Technical Service Bulletin

REAR DOOR LOWER GARNISH CRACKING

Bulletin No.: 09-034/19

Last Issued: 08/30/2019

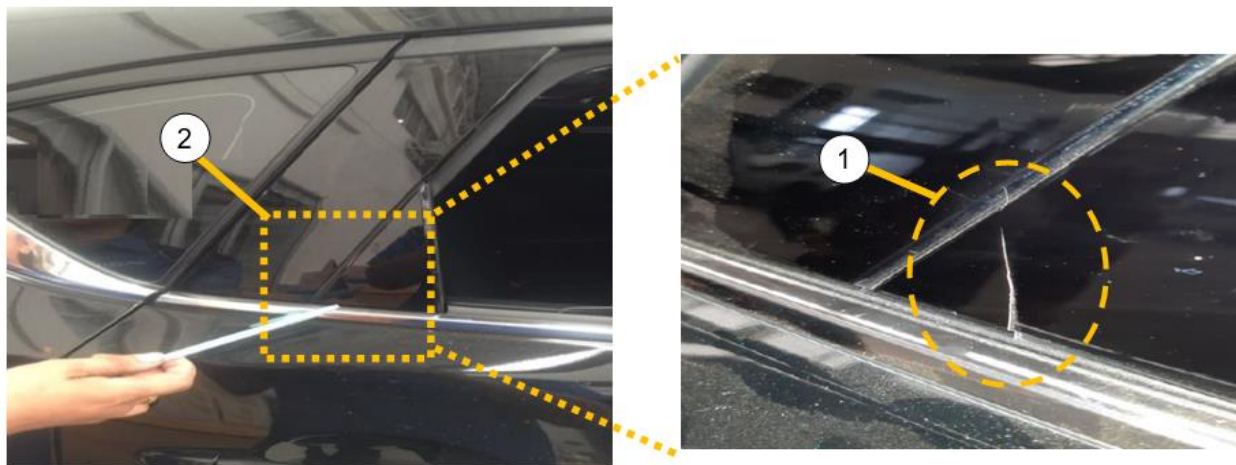
Some vehicles may exhibit cracking (1) at the lower part of the rear side, rear door garnish (2). This concern is caused by excess stress applied to the rear door garnish. To eliminate this concern, the clip and tape position on the rear door garnish has been improved.

1. Verify the customer concern.
2. Replace the rear side, rear door garnish with a modified part according to the instructions on MGSS online (REAR DOOR GARNISH REMOVAL/INSTALLATION).
3. Verify the repair.
